## **UNNECESSARY SUBDIVISION**

Engineering Comments: The following comments should be addressed prior to submitting the FINAL PLAT for acceptance and signature by the City Engineer:

APPLICATION NUMBER 4 DATE June 2, 2016

# DETAIL SITE PLAN

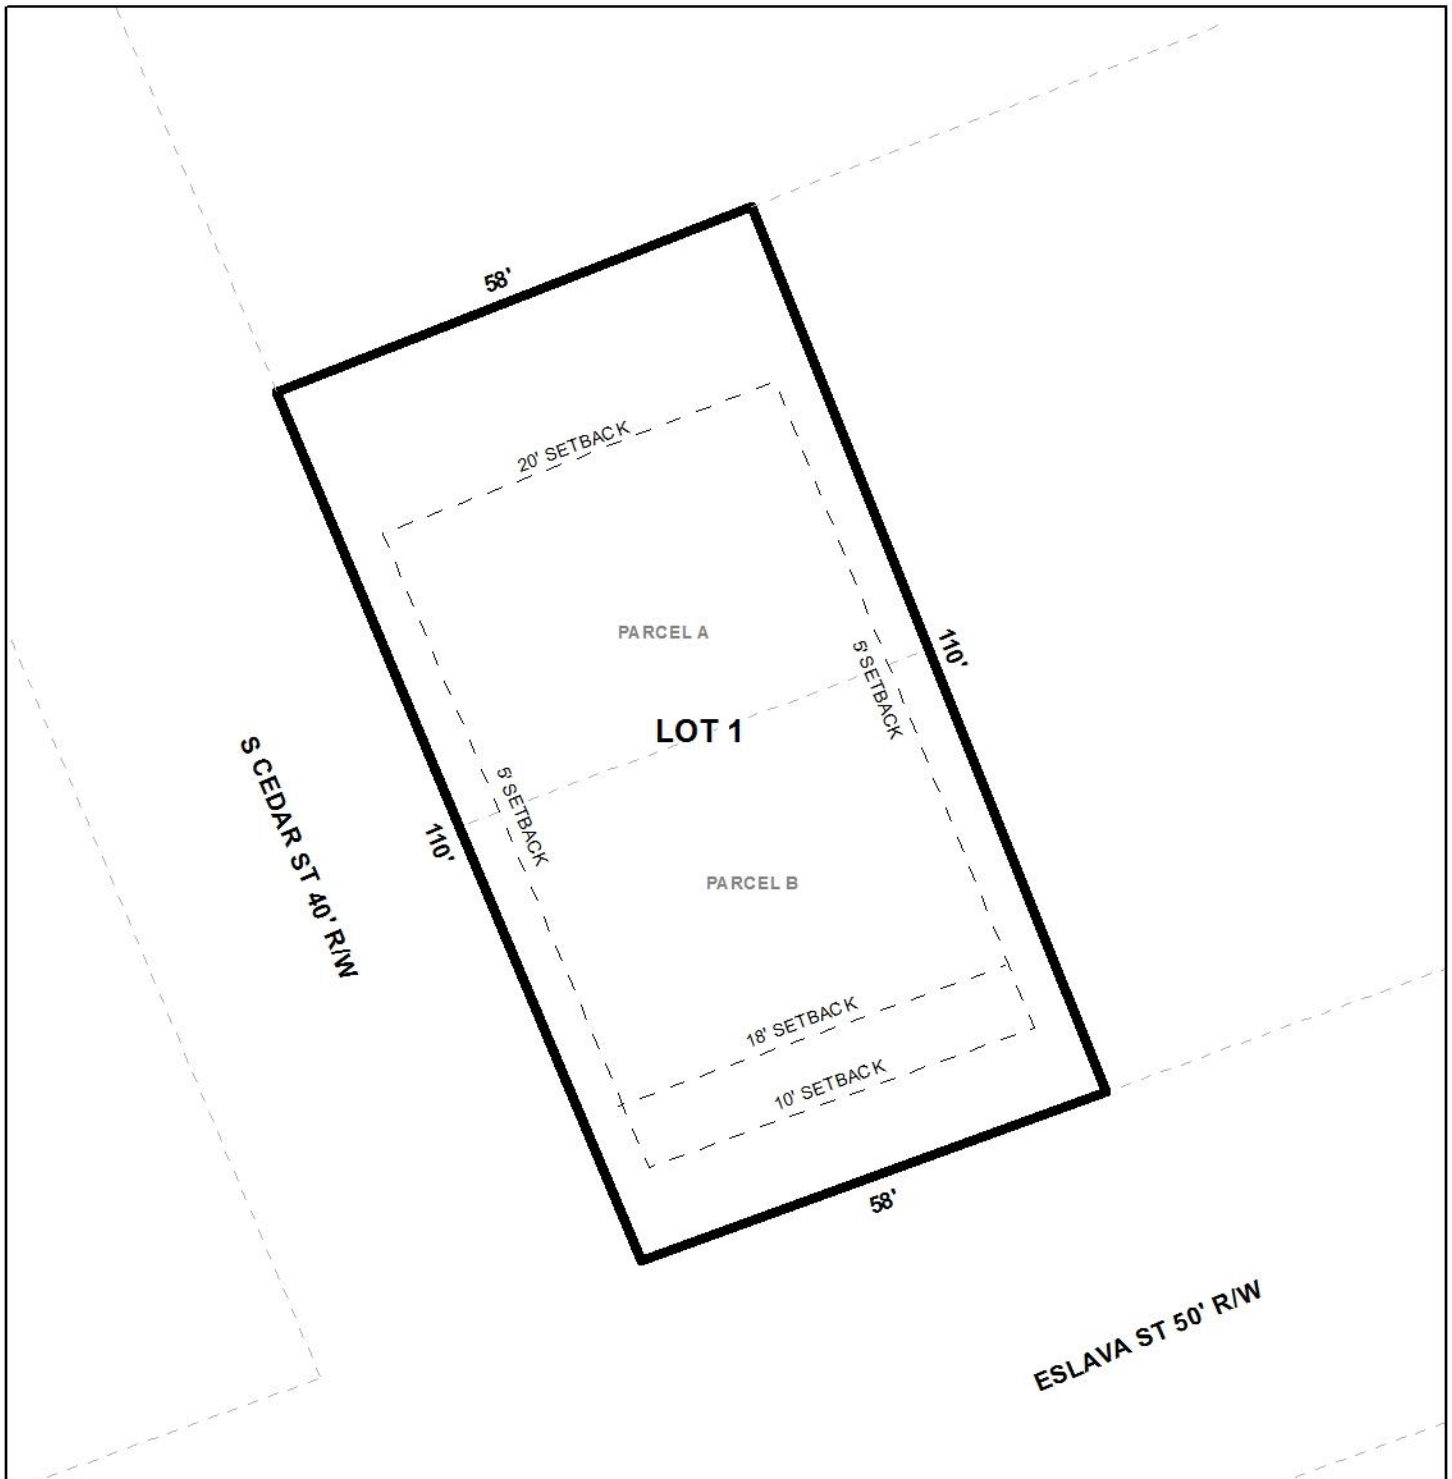
The proposed lot, located in the Church Street East Historic District, as well as in a T-3 Sub-District of the Downtown Development District, is a corner lot with frontage along Eslava Street and South Cedar Street, both "B" streets with curb and gutter. A compliant 50' right-of-way is depicted along Eslava Street and, as such, no dedication is required. It should be noted that South Cedar Street appears to have a 40' right-of-way and dedication to provide 25' from the centerline of the street would normally be required; however, other subdivisions along South Cedar Street since at least the late-1970s have not required right-of-way dedication, thus a waiver may be appropriate. Dedication of the corner radii at Eslava Street and South Cedar Street should nevertheless be required, and illustrated, per Section V.D.6. of the Subdivision Regulations to provide a minimum 20' radius.

In keeping with the character of the surrounding neighborhood, the site should be limited to one curb cut to South Cedar Street, with any changes in its size, design, and location to be approved by Traffic Engineering and conform to AASHTO standards.

The proposed lot, as depicted, does not meet the minimum area requirements as regulated by the Subdivision Regulations. However, as the site is within the Downtown Development District, different lot regulations apply. As such, the area, width and setback requirements of the Subdivision Regulations should be waived to allow for the provisions of the Downtown Development District regarding subdivisions in T-3 Sub-Districts.

The plat illustrates the size of the lot in both square feet and acres and this information should be retained on the Final Plat, or a table providing the same information should be furnished on the Final Plat, if approved.

The building setback lines along Eslava Street and South Cedar Street, requirements of the Downtown Development District regulations, are shown on the preliminary plat and should be retained on the Final Plat, if approved.

- 1) revision of the Final Plat to illustrate dedication of the corner radii at Eslava Street and South Cedar Street to provide a minimum 20' radius if determined necessary by the City Engineer;
- 2) a note on the Final Plat stating the lot is limited to one curb cut to South Cedar Street, with any changes in its size, design, and location to be approved by Traffic Engineering and conform to AASHTO standards;

- 3) retention of the lot sizes in square feet and acres on the Final Plat, or the furnishing of a table on the Final Plat providing the same information, adjusted for dedication;

- 4) retention of the minimum building setback lines along Eslava Street and South Cedar Street on the Final Plat;
- 5) compliance with Engineering comments: *(The following comments should be addressed prior to submitting the FINAL PLAT for acceptance and signature by the City Engineer: A) Provide all of the required information on the SUBDIVISION PLAT (i.e. signature blocks, signatures, certification statements, written legal description, required notes, legend, scale, bearings and distances) that is required by the current Alabama State Board of Licensure for Professional Engineers and Land Surveyors. B) Show and label the MFFE (Minimum Finished Floor Elevation) on each lot that contains an AE, V, or X (shaded) flood zone designation. C) Provide and label the monument set or found at each subdivision corner. D) Add a signature block for the Planning Commission, Traffic Engineer, and City Engineer. E) Provide the Surveyor's, Owner's (notarized), Planning Commission, and Traffic Engineering signatures. F) Add a note to the SUBDIVISION PLAT stating that a Land Disturbance permit will be required for any land disturbing activity in accordance with Mobile City Code, Chapter 17, Storm Water Management and Flood Control; the City of Mobile, Alabama Flood Plain Management Plan (1984); and, the Rules For Erosion and Sedimentation Control and Storm Water Runoff Control. G) Add a note to the Plat stating that the approval of all applicable federal, state, and local agencies (including all storm water runoff, wetland and floodplain requirements) will be required prior to the issuance of a Land Disturbance permit. H) Provide a copy of the FINAL PLAT to the Engineering Dept. for FINAL PLAT review prior to obtaining any signatures. I) After FINAL PLAT review by the Engineering Dept. provide a copy of the Final Plat along with the original and any review copies when submitting for City Engineer signature.);*
